Access Compliance Report

Intersection ID: 15034	Main Street: OLMSTED_PARK_PL	Cross Street: SUMNER_GREEN_AV	Location: E
ADA ID: 9B099C1B61F3	Ramp Type: Perp	Initial Pass/Fail: Fail	Overall Compliance: No
Severity Score: 1.25			
Codes/Mitigation Info/Possible Solution		Field Measurements/Component Compliance

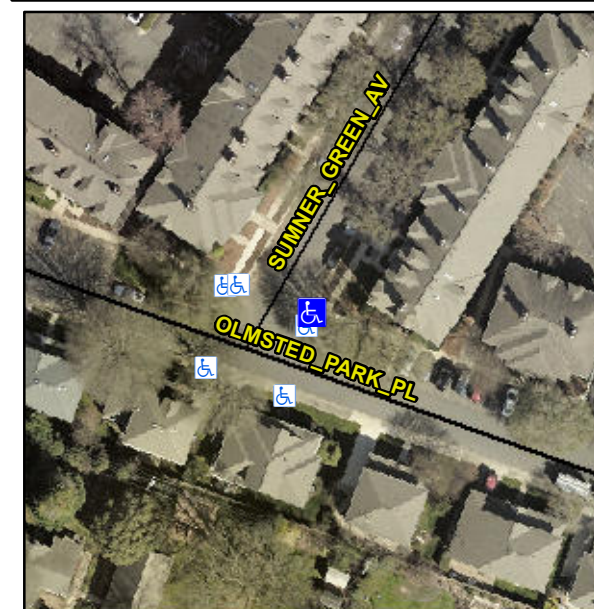
Not Found, R304.5.3

Compliance	Description	Data	Compliance	Description	Data
N/A	Ramp Length (in)	82.0	Yes	Ramp Slope (%)	5.1
Yes	Ramp Width (in)	48.0	No	Ramp XSlope (%)	2.8
N/A	Flare Type LT	N/A	N/A	Flare Type RT	N/A
N/A	Flare Slope LT (%)	N/A	N/A	Flare Slope RT (%)	N/A
N/A	Flare Traversable LT?	N/A	N/A	Flare Traversable RT?	N/A
N/A	Landing Length (in)	N/A	N/A	DWS Provided?	N/A
N/A	Landing Width (in)	N/A	N/A	DWS Contrast?	N/A
N/A	Landing Slope (%)	N/A	N/A	DWS Length (in)	N/A
N/A	Landing X Slope (%)	N/A	N/A	DWS Full Width?	N/A
N/A	Landing Curb? (Y/N)	N/A	N/A	DWS Offset (in)	N/A
N/A	Shared Landing?	N/A			
N/A	Gutter Ponding?	N/A	N/A	Gutter Slope (%)	N/A
N/A	Gutter Lip Ht (in)	N/A	N/A	Gutter X Slope (%)	N/A
N/A	Painted X Walk1?	No	N/A	Painted X Walk2?	N/A
	X Walk 1 Direction	To NW		X Walk 2 Direction	N/A
N/A	X Walk 1 Width (in)	N/A	N/A	X Walk 2 Width (in)	N/A
	X Walk 1 Slope (%)	3.9		X Walk 2 Slope (%)	N/A
	X Walk 1 X Slope (%)	2.2		X Walk 2 X Slope (%)	N/A

Remove & Replace Entire Ramp.
